**CITY OF LA VISTA
MAYOR AND CITY COUNCIL REPORT
SEPTEMBER 18, 2018 AGENDA**

Subject:	Type:	Submitted By:
APPLICATION FOR PUD SITE PLAN – LOT 1, ROTELLA’S FIRST ADDITION, LOTS 4, 5, 6, 15, 16, 17, AND 28A OAKDALE PARK, AND TAX LOT 8A2 (108 TH ST & HARRISON ST)	◆ RESOLUTION ◆ ORDINANCE RECEIVE/FILE	CHRISTOPHER SOLBERG CITY PLANNER

RE: Rotella's Italian Bakery
Site Development Plan
Proposed Planned Unit Development (PUD) Site Plan - Initial Review

RE: Rotella's Italian Bakery
Site Development Plan
Proposed Planned Unit Development (PUD) Site Plan – 2nd Review

- LEGEND**
- LOCAL TRAFFIC BETWEEN BUILDINGS
 - IN-BOUND DELIVERIES
 - OFF-SITE TRAFFIC - DISTRIBUTION
 - NEIGHBORHOOD TRAFFIC

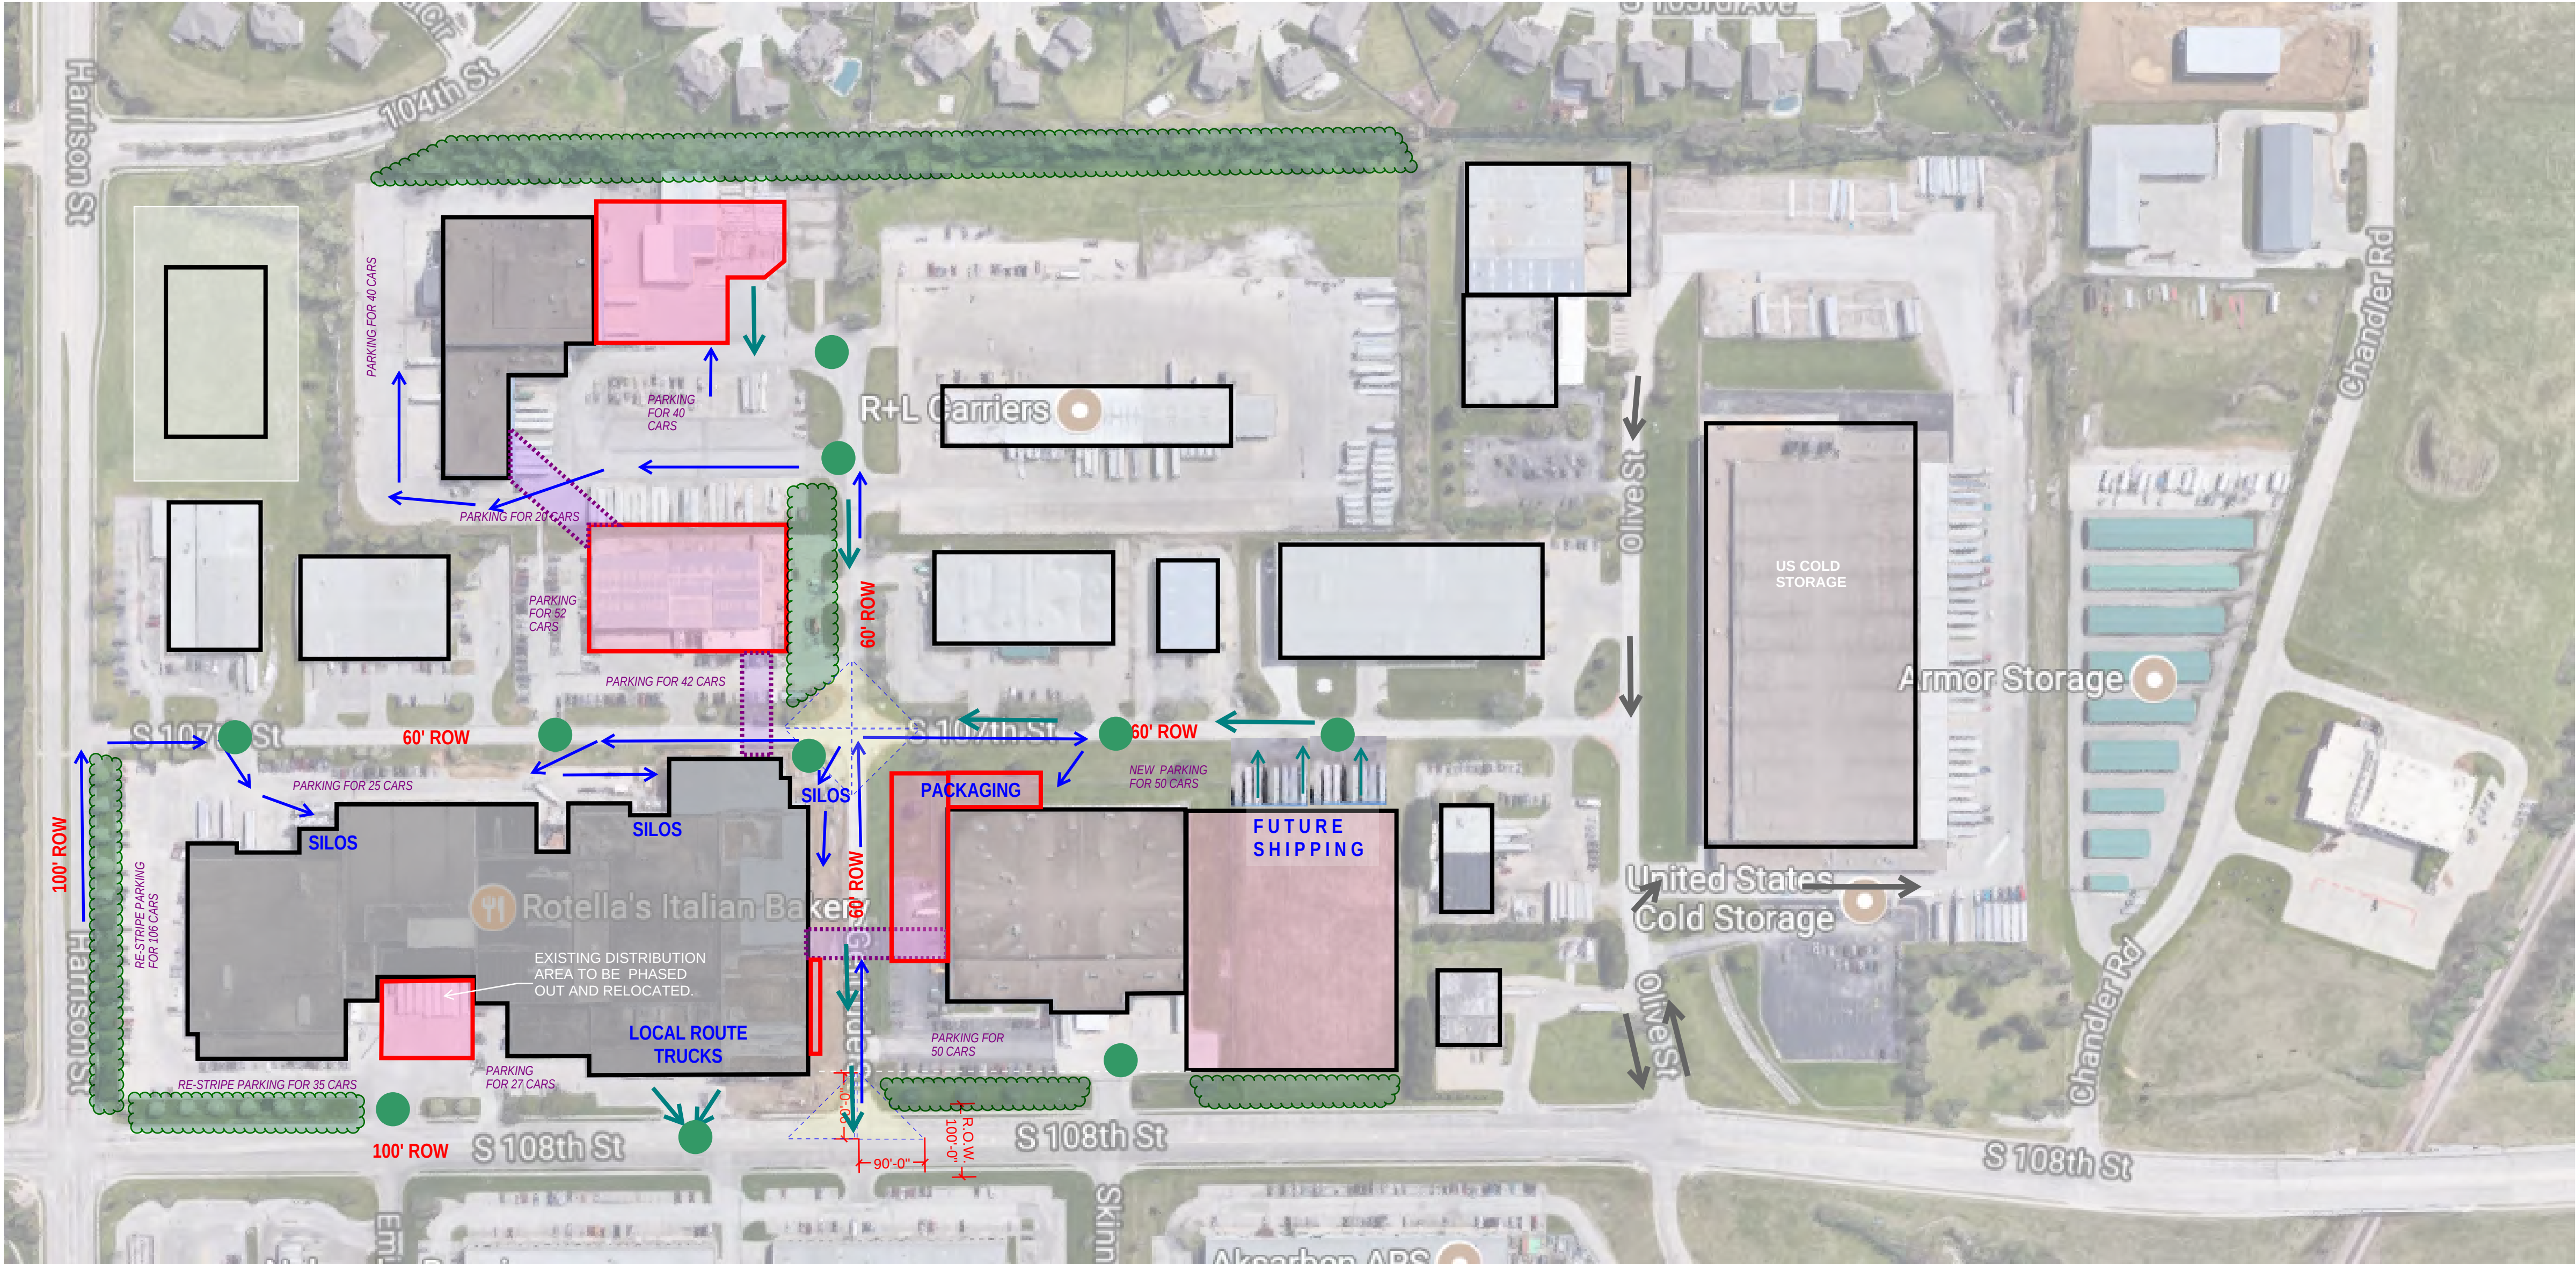
4. Article 5.15.04.03: Attachments 6 and 7 in the PUD binder present information on existing truck traffic between buildings, inbound supplies, and outbound products. In order to determine the adequacy of roadways to serve the development additional information is needed. The truck count information that is provided in Attachments 6 and 7 should be updated to include projected volumes at the end of Phase A5. The PUD plan should address whether the local delivery trucks will be using a different access point than the current driveway onto 108th Street. There needs to be information as to traffic generated by the retail operation now and in the future and the access points to be used by the retail traffic. The peak hour volumes and times related to the retail operation are needed. When this information is provided, we can determine if a traffic impact study may be required at some future point in the development of this PUD plan.

- i) Comment: Revise Attachments 6&7 to show projected truck volume at end of Phase 5.
- ii) Response:

- (1) Outbound truck traffic is of two type: Local route delivery trucks and long distance semi traffic.
 - (a) Local delivery route trucks (20 per day) are not expected to change in the near term. One of the last phases will involve consolidation of shipping, adjacent to the future cold storage facility. At that time some of the route truck would likely move from 108th street.

- (3) See **Table 3D** for traffic recap, and a site diagram of future truck traffic patterns has been added.

FUTURE TRAFFIC DIAGRAM & PARKING
INBOUND DELIVERIES TO BAKERY
BAKERY - OUTBOUND
PARKING REQUIREMENTS LISTED IN PURPLE.

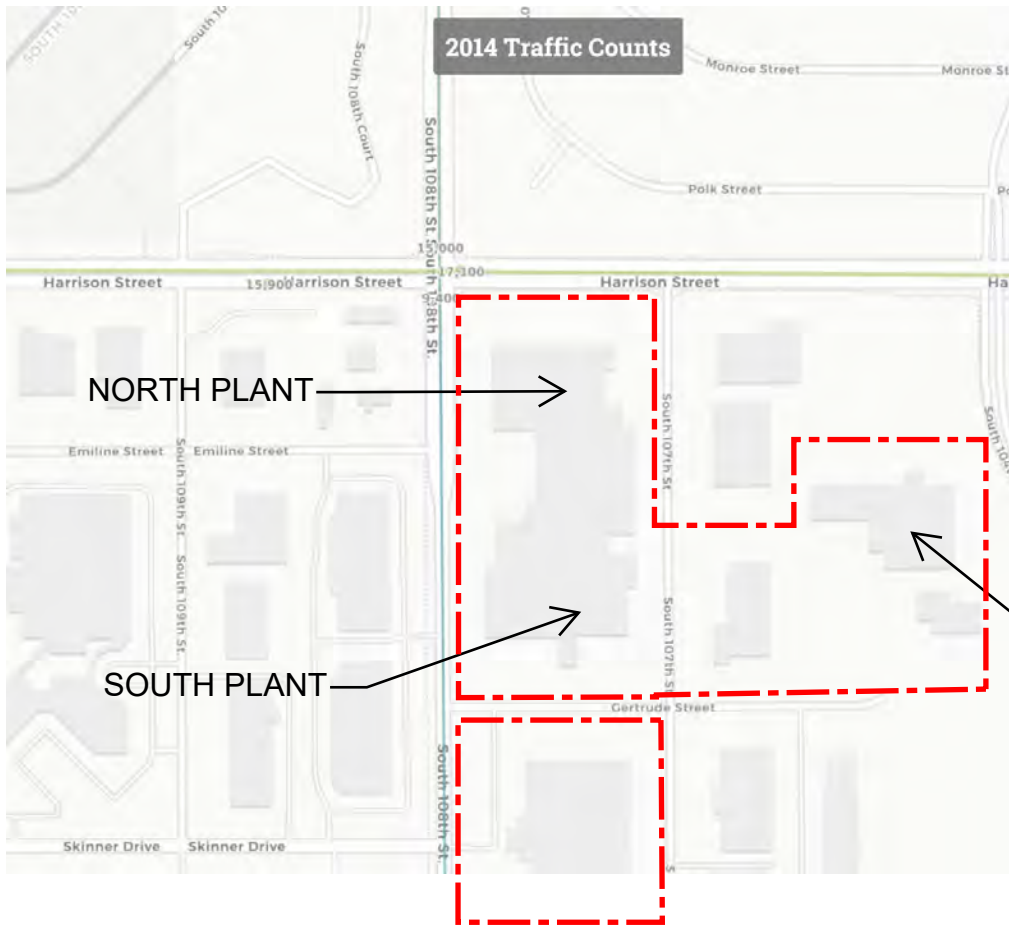
1. On Attachment 4a-Future Traffic Diagram, it indicates that the estimated average daily long-distance, outbound trucks will be 70 per day in lieu of the current 60 trucks per day leaving the U.S. Cold Storage Facility. On the assumption that U.S. Cold Storage will replace the lost business with other customers, there could be an increase of 70 trucks per day entering onto 108th Street. The applicant should identify how many of the 70 trucks might occur during peak hour.

- 1) Item 1 -
 - a. Regarding **Table 3D – Future Truck Traffic:**
 - i) **Comment:** On the assumption that US Cold Storage will replace the lost business with other customers there could be a net increase of 70 trucks per day entering 108th street. Also, identify how many of the 70 trucks might occur during peak hours.

- ii) **Response:**
 - (1) The Rotella automated cold storage facility would operate 24/7, and would be designed for future outbound traffic of 70 trucks per day. These would be distributed throughout the day. The estimated traffic load is 3 trucks per hour average, with a peak of 6 per hour. The calculation is based on the following assumptions:

- (3) See revised **Table 3D** for traffic volume recap, and the revised **Future Traffic Diagram** has been added.
